Device	XMC1400
Marking/Step	EES-AA, ES-AA, AA
Package	PG-VQFN-40/48/64, PG-LQFP-64, PG-TSSOP-38

Overview

This “Errata Sheet” describes product deviations with respect to the user documentation listed below.

Figure 1 CCU8 simplifier PWM generation scheme - a) normal mode; b) asymmetric mode

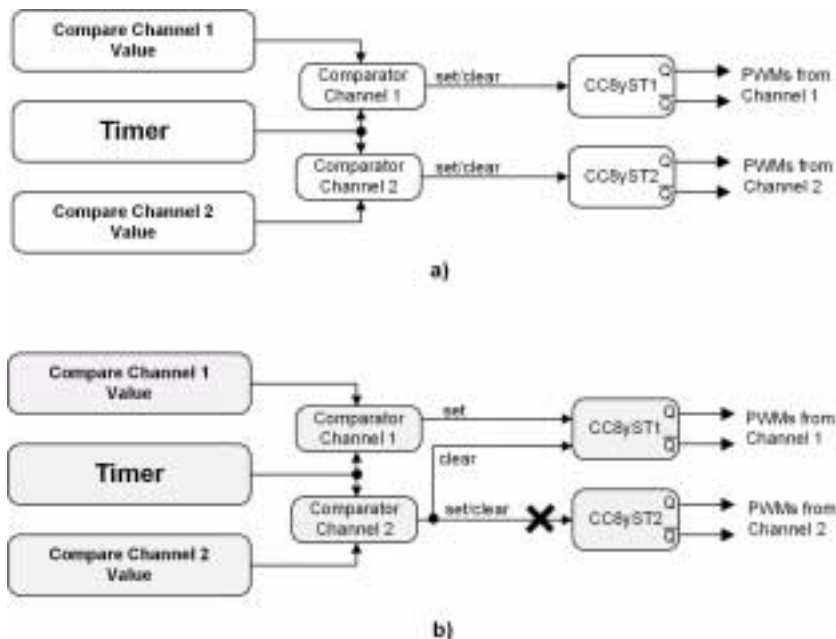
The asymmetric mode has a bug, where the PWM signal of Compare Channel 2 is not stored in CC8yST2. This means that from the Compare Channel 2 the timer cannot generate any PWM signal - depicted by the cross on **Figure 1 b)**.

None

Figure 2 CCU8x concatenation feature resource configuration - a) without external count function; b) with external count function

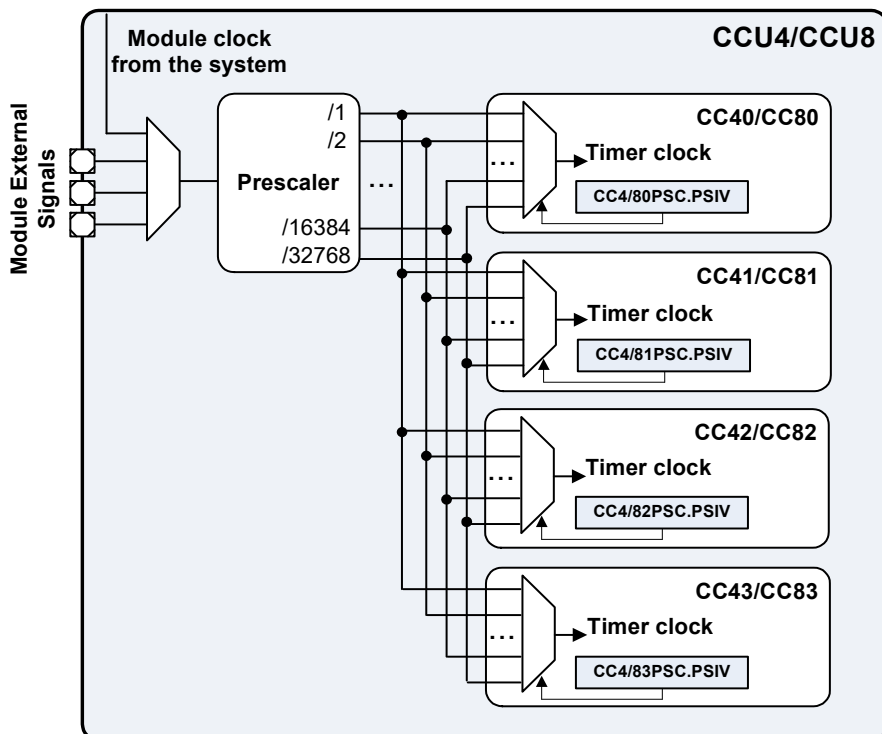
When an external count signal is enabled - by programming the CC8yCMC.CNTS with 01_B, 10_B or 11_B - the concatenation function does not work. One cannot use in parallel the timer concatenation and external count signal features.

Note: On Figure 1, the count signal is used in CCU80 because this timer represents the LSBs. While the count signal could be enabled in the MSB timer (CC81), this does not make sense when the timers are concatenate - because the count should be used to increment the LSB timer. The LSB timer will then in each wrap around, increment the MSB timer.

None
